Subject: V. C. Summer Nuclear Station Units 2 and 3  
Docket Numbers 52-027 and 52-028  
Combined License Application – Environmental Report Audit  
Information Needs: ACC-5 (Item 1), AQ-9, BC-1, GW-7 (Item 3)  
and SE-S1

During the week of March 9, 2009, the NRC conducted an Environmental Audit to gather information to assist in the review of the ER. The purpose of this letter is to submit a portion of the ER Information Needs identified by the NRC including: ACC-5 (Item 1), AQ-9, BC-1, GW-7 (Item 3) and SE-S1.

### Response to NRC Information Needs Item

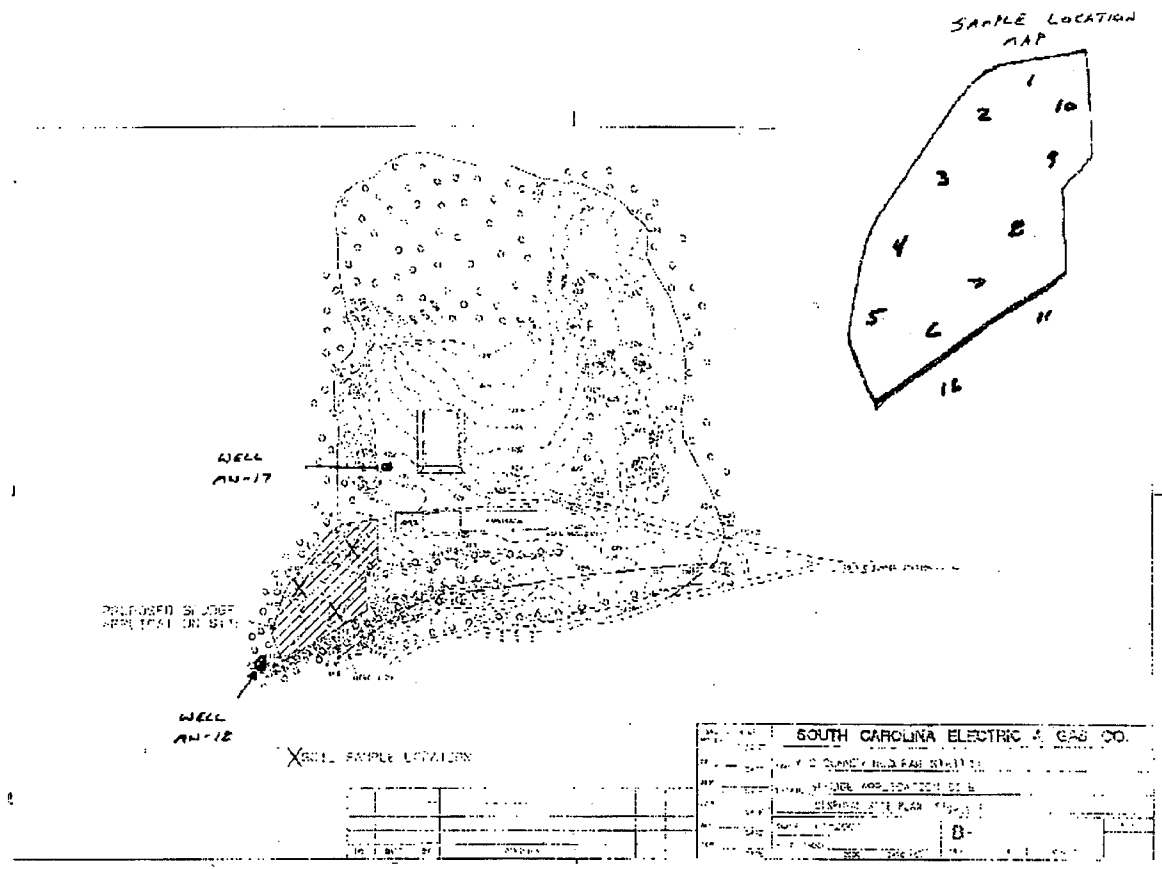
Provide an expert to describe baseline groundwater quality at the site along with spatial and temporal changes.

Provide letter from applicant to DHEC and response letter from DHEC dated January 11, 2007 that discusses condensate polisher resin disposal.

Attached is the requested correspondence between DHEC and SCE&G dated January 11, 2007 and August 22, 2006,

This is a 1.37 acre site approximately 0.75 miles south of VC Summer Nuclear Station in the area of L-50. See attached map for reference.
